HRM - Stormwater and Erosion Overview Map

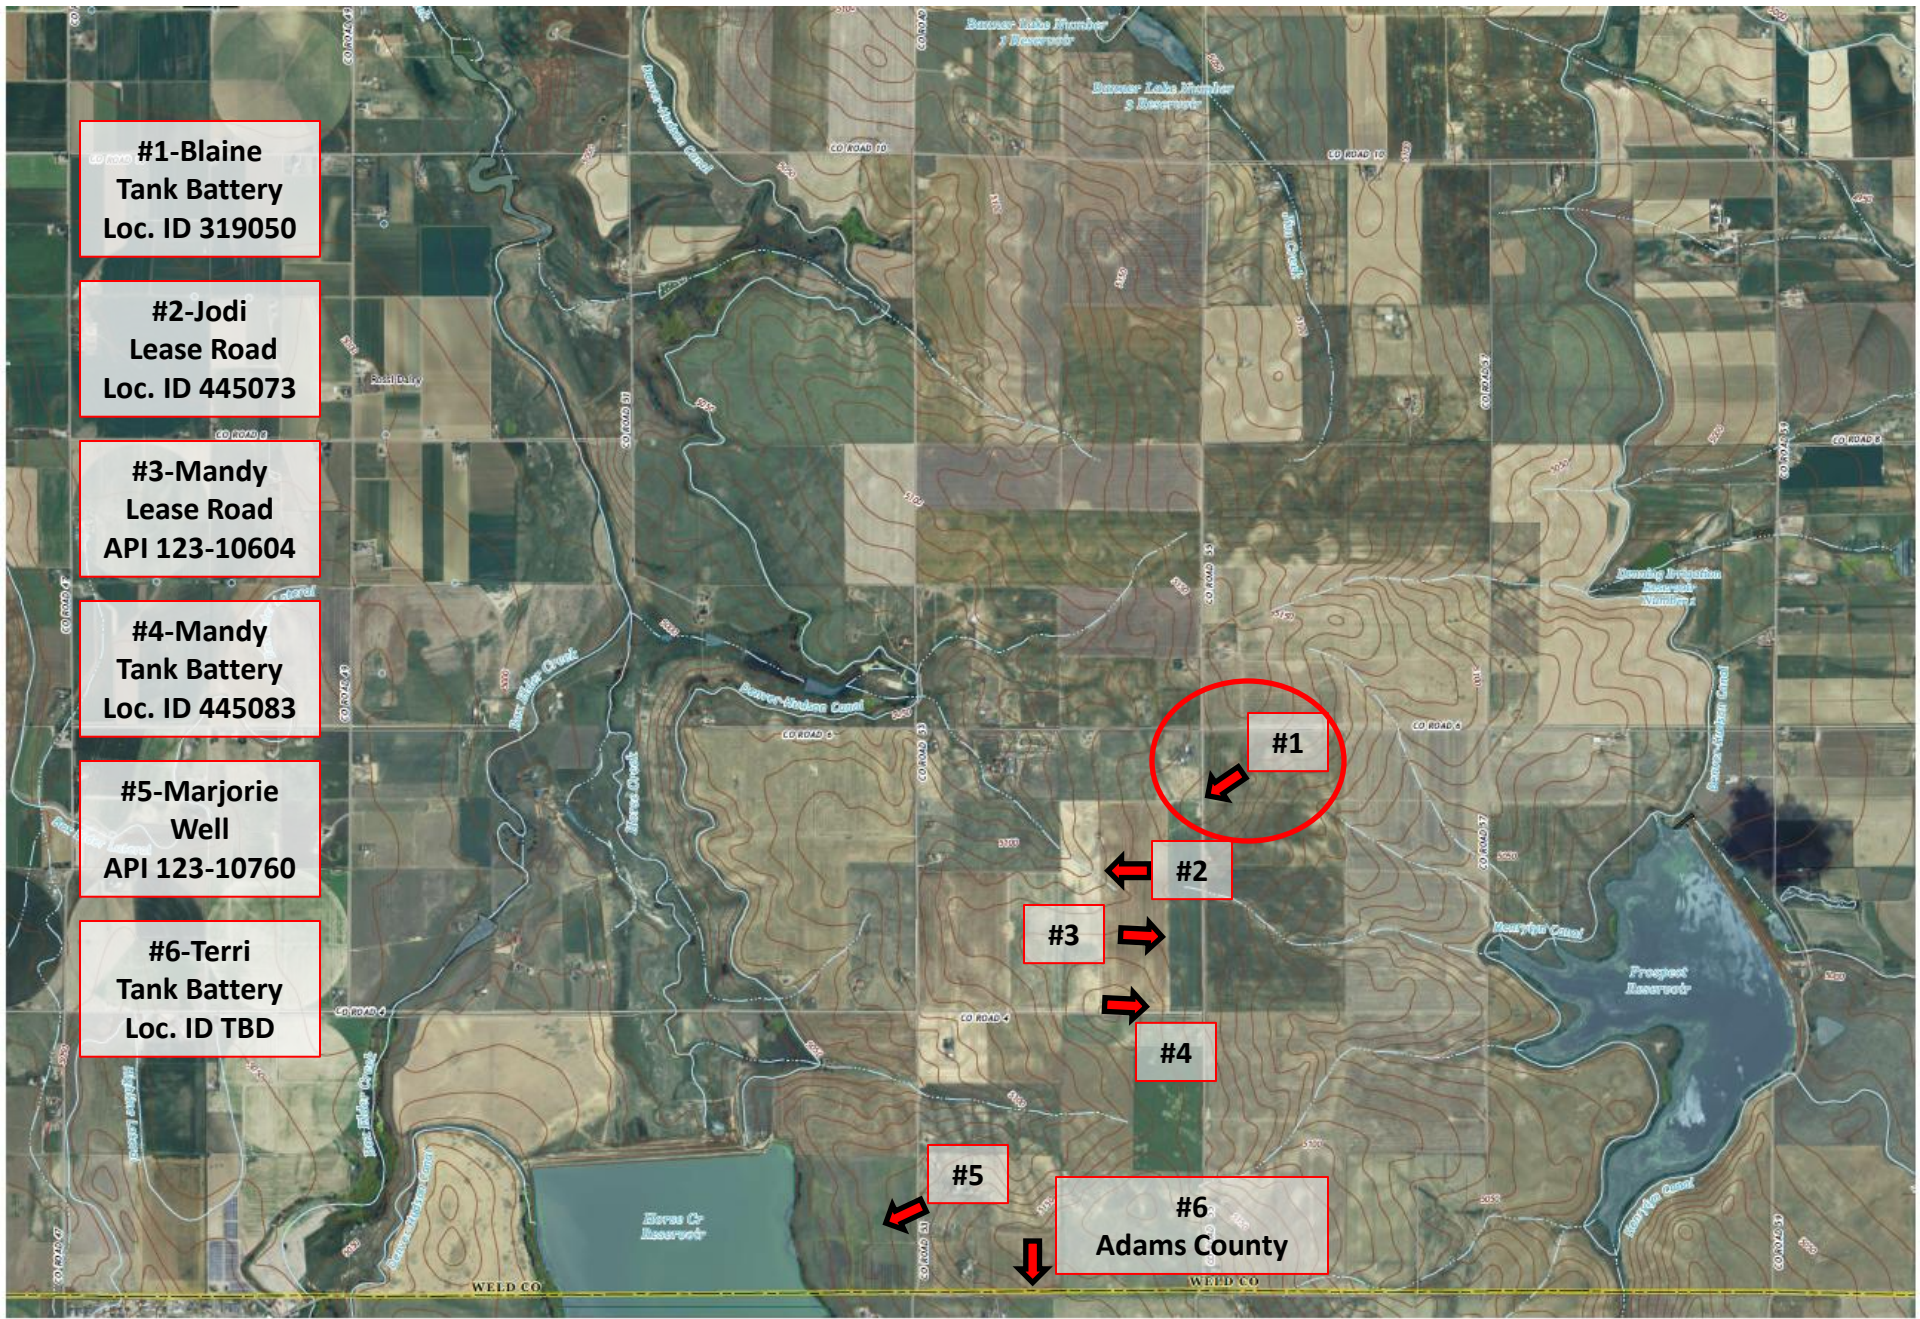
Photo 1: Aerial imagery illustrating erosion and transport of sediment initiates on location, traveling southwest onto cropland. Refer to Document# 682400493 for complete field photos from the 3/8/16 inspection.

Photo 2: Photo taken 3/8/16 from the southern tank battery location, facing Southwest. Need to control stormwater runoff that minimizes erosion and transport of sediment offsite per Rule 1002.

Photo 3: Photo taken 3/8/16 from the southern tank battery location, facing North. Need to control stormwater runoff that minimizes erosion and transport of sediment offsite per Rule 1002.

Photo 4: Photo taken 3/8/16 from the southern tank battery location, facing Northeast. Need to control stormwater runoff that minimizes erosion and transport of sediment offsite per Rule 1002.

Photo 5: Photo taken 4/19/16 from southern tank battery location, facing West. Installed wattles around south, southwest location. Wattles not properly installed- see following photos.

Photo 6: Photo taken 4/19/16 from southern tank battery location, facing West. Installed wattles around south, southwest location. Wattles not properly installed-transport of sediment still occurring.

Photo 7: Photo taken 4/19/16 from southwest tank battery location, facing Southeast. Installed wattles around south, southwest location. Wattles not properly installed-transport of sediment still occurring.
